Customs Convention on the International Transport of Goods under Cover of TIR Carnets (TIR Convention, 1975):

Application of the Convention – Vehicles with sliding sheets

Submitted by the International Association of the Body and Trailer Building Industry

Sketch No. 10

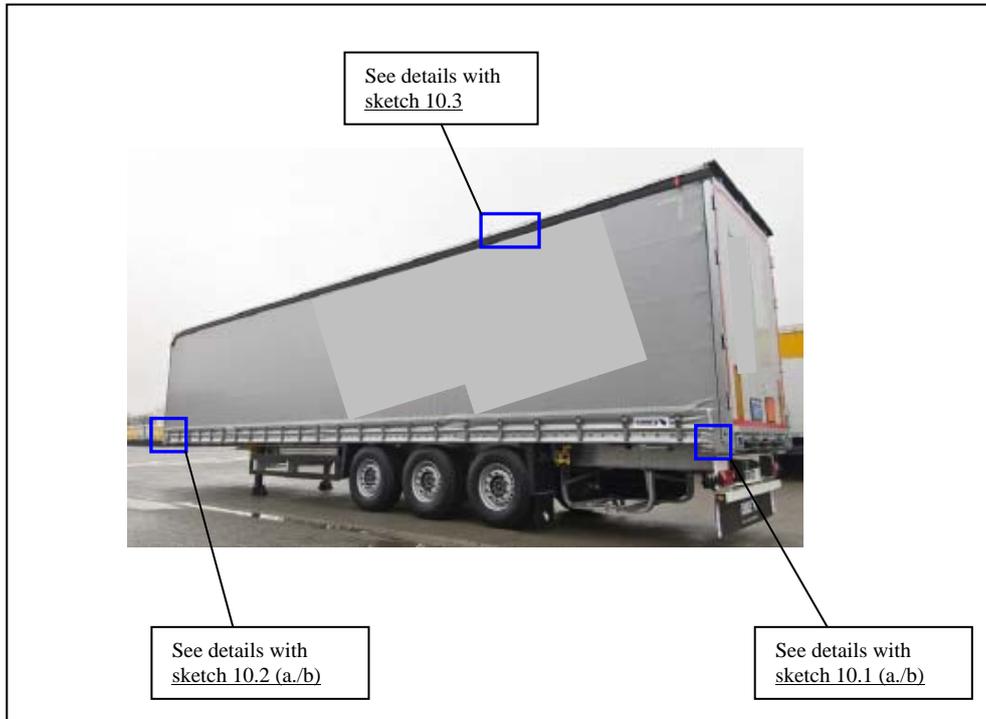
(iv) The sliding sheet guidance and other movable parts shall be assembled in such a way that when closed, and Customs sealed, doors and other movable parts cannot be opened or closed from the outside without leaving obvious traces. The sliding sheet guidance and other movable parts shall be assembled in such a way that it is impossible to gain access to the load compartment without leaving obvious traces. The system is described in sketch No. 9 and No. 10 appended to these Regulations;

This sketch shows an example of a vehicle and of important points described within Annex 2, Article 4, paragraph 3.

Sketch No. 10.1

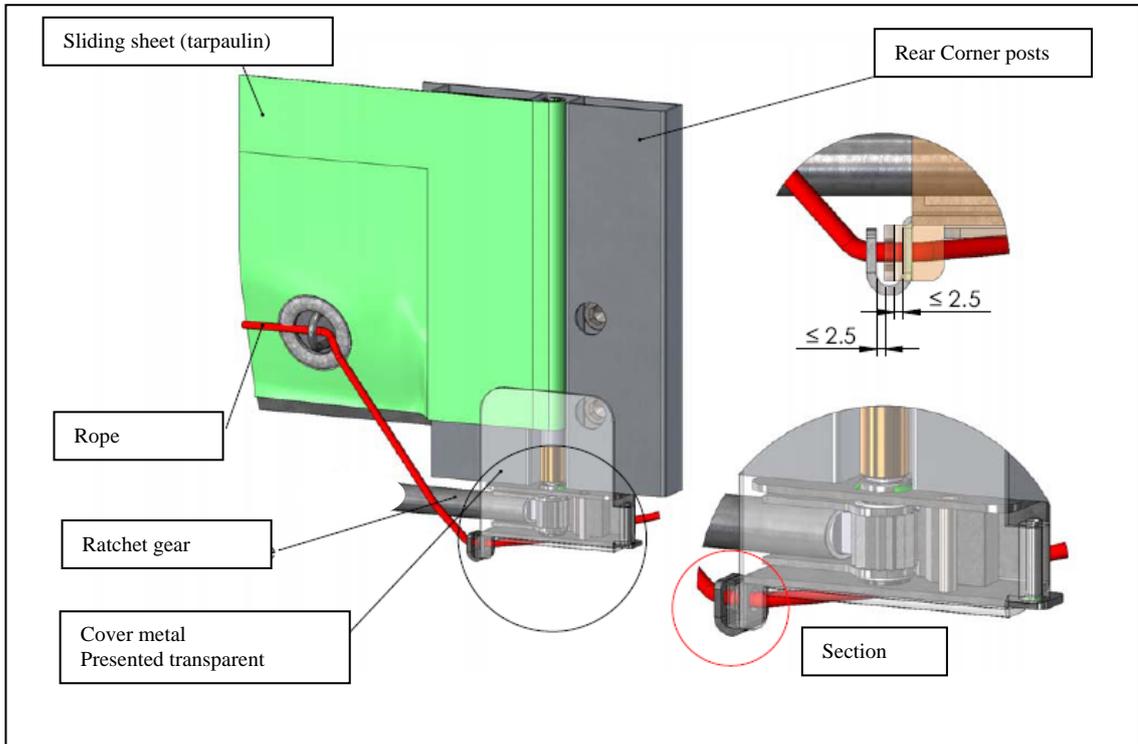
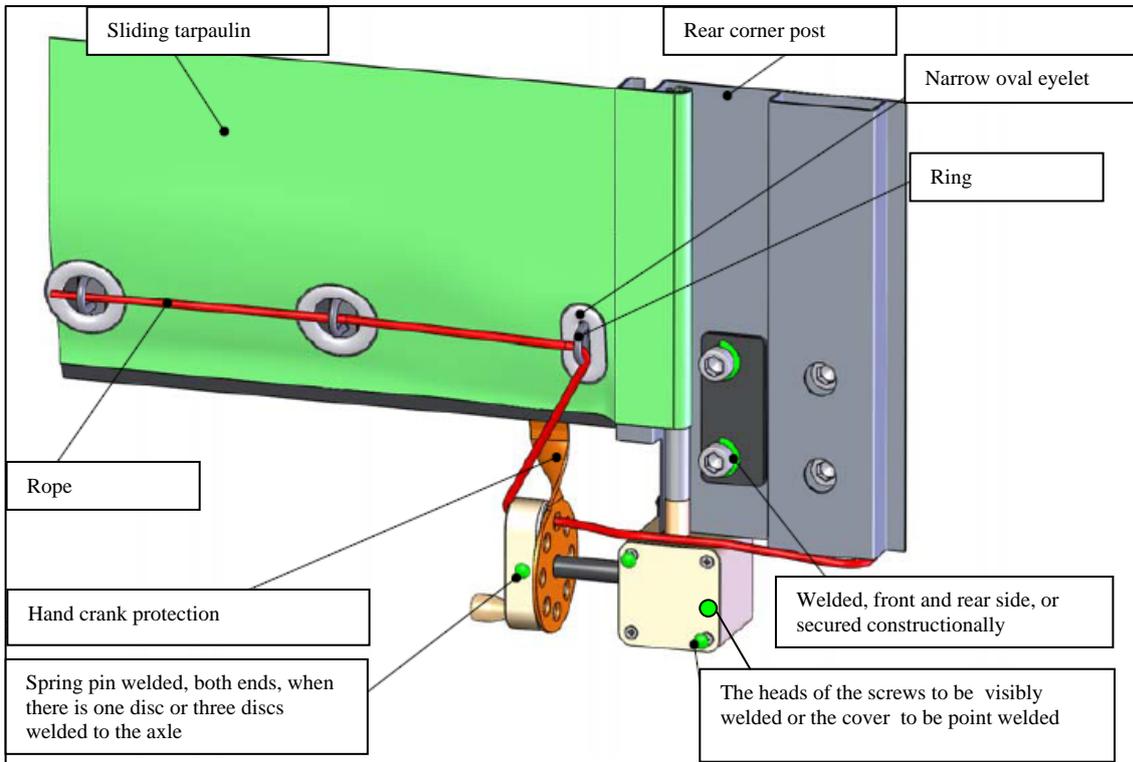
To tighten the tarpaulin in the horizontal direction, a ratchet gear is used (normally on the rear end of the vehicle). This sketch shows two examples (a) and (b) how the ratchet or gearbox may be secured.

Sketch No. 10.2

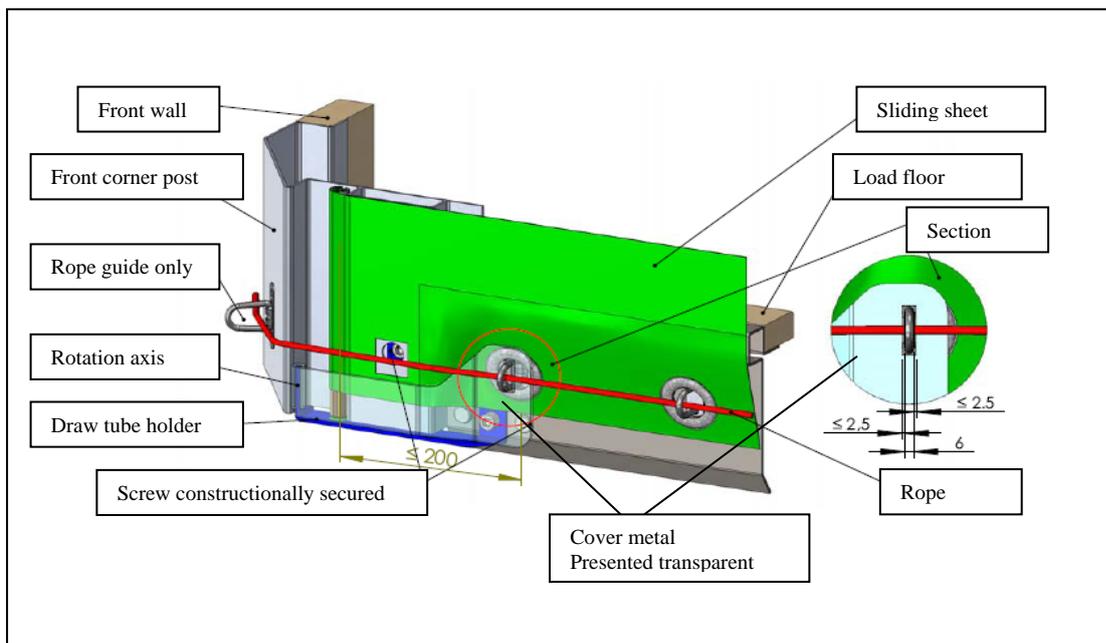
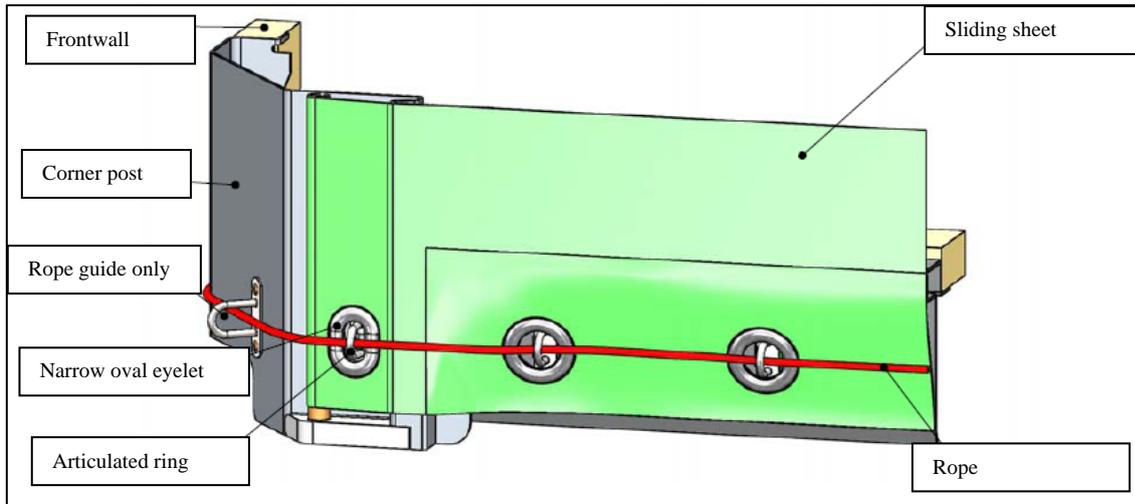
To fix the tarpaulin on the other side (normally to the front of the vehicles) the following systems (a) or (b) may be used.

Sketch 10.3

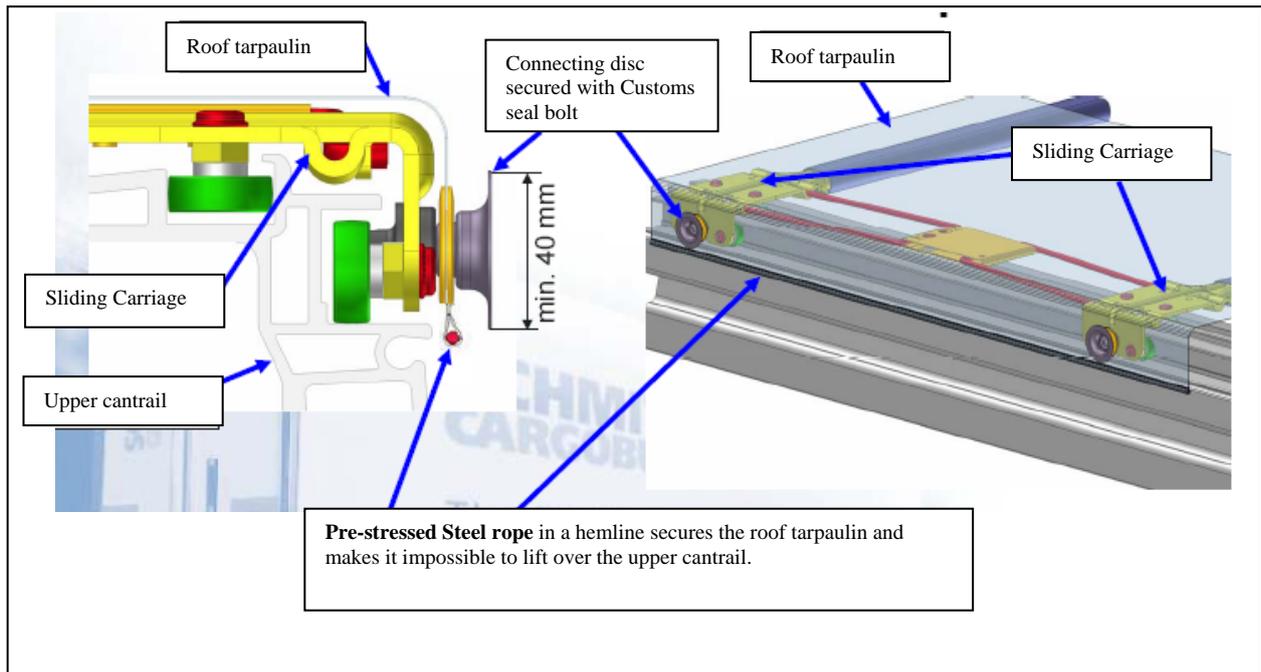
(iii) The sliding roof curtain shall overlap the solid part of the roof at the side of the vehicle, so that the roof curtain cannot be pulled over the top edge of the upper cantrail. In the hemline of the roof curtain a pre-stressed steel rope (minimum z_k 1770 N/mm², 6x19+SE) shall be inserted in such a way that it cannot be removed and re-inserted without leaving obvious traces. The roof curtain shall be secured to the sliding carriage in such a way that it can not be removed and re-secured without leaving obvious traces. The system is described in sketch No. 10.3 appended to these Regulations;

The Customs security of the sliding roof is guaranteed if a pre-stressed steel rope, embedded in a hemline, is fixed. This steel rope is fixed to the front and rear of the vehicle. The tractive force as well as the connecting disc on each sliding carriage, makes it impossible to lift up the hemline with the steel rope above the upper cantrail.
